AEMO submission on APA Rule 80 application for expansion of the South West Pipeline

Executive summary

Introduction

Figure 5 South West Pipeline expansion locations

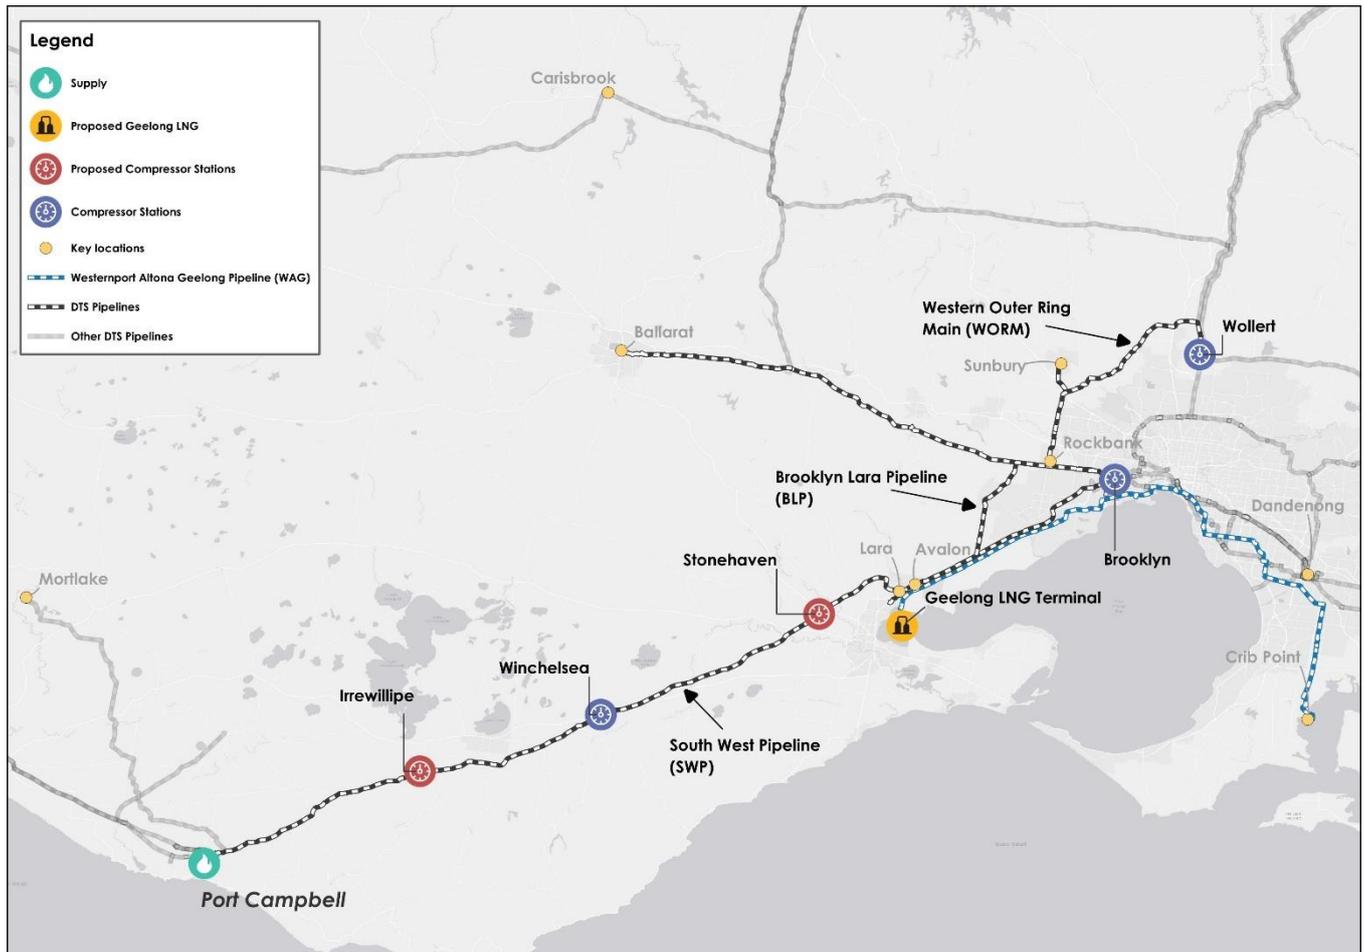
In response to forecast peak day shortfalls from 2028 and Lochard Energy making FID on the expansion of Iona UGS to 615 TJ/d in July 2024, APA lodged an application with the AER on 31 October 2025 for an advanced determination of capital expenditure for the Victorian Transmission System under Rule 80. APA has proposed a preferred option of expanding the SWP through the installation of two new 10 MW compressors at Stonehaven and Irrewillipe and reconfiguring the Winchelsea CS to enable the two compressors to operate in parallel. **Figure 5** shows a map of the SWP and proposed compressor stations.

Figure 6 Port Campbell hub and Geelong LNG regasification terminal interaction

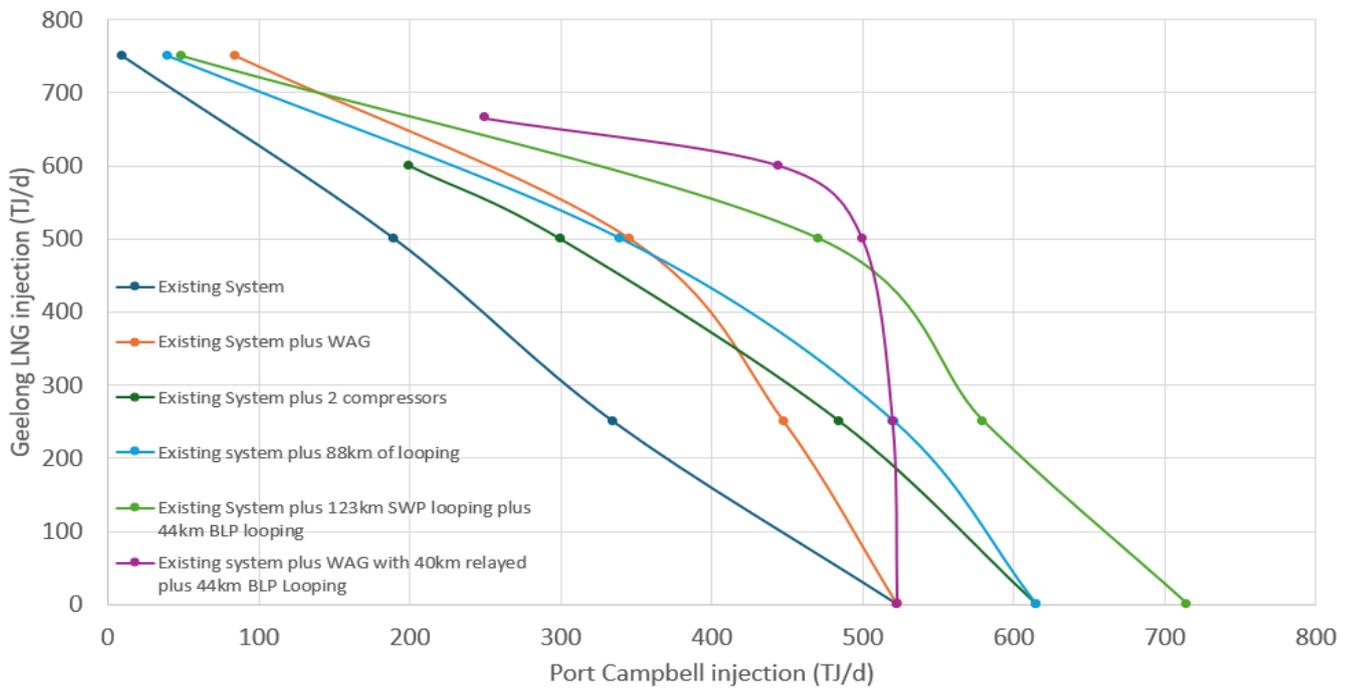
The connection of a Geelong LNG regasification terminal would increase pipeline capacity at the expense of backing off Port Campbell injections. AEMO has modelled interaction between APA’s proposed SWP augmentation and potential connection of an LNG regasification terminal at Geelong. The different options of SWP augmentation would mitigate the back-off effect to different extents. A summary of back-off effect modelling completed by AEMO is shown in **Figure 6**.

The option of partially duplicating the SWP between Port Campbell to Lara provides a similar capacity increase to the compression option. The pipeline looping options, however, do not have the same flow dependency limitations as the compression option and can be operated over broad combinations of injection flow ranges.

A further reduction of the back-off effect impacting Port Campbell supply due to the introduction of a Geelong LNG regasification terminal can be achieved with additional pipeline looping between Lara and Rockbank, downstream of where the LNG regasification terminal may connect to the SWP. The modelling results presented above in **Figure 6** illustrate a further reduction in back-off effect, achieved through the implementation of 44 km of BLP looping from Lara to Rockbank alongside 123 km of SWP looping from Port Campbell to Lara. This modelling option could facilitate high concurrent modelled supply capacities at both Port Campbell and the LNG regasification terminal, with capacities of 555 TJ/d and 500 TJ/d, respectively. Additional overall capacity can also be enhanced from this option with the addition of the WAG Pipeline increasing total capacity up to 1,230 TJ/d of with 615 TJ/d from LNG receiving and 615 TJ/d from Port Campbell.
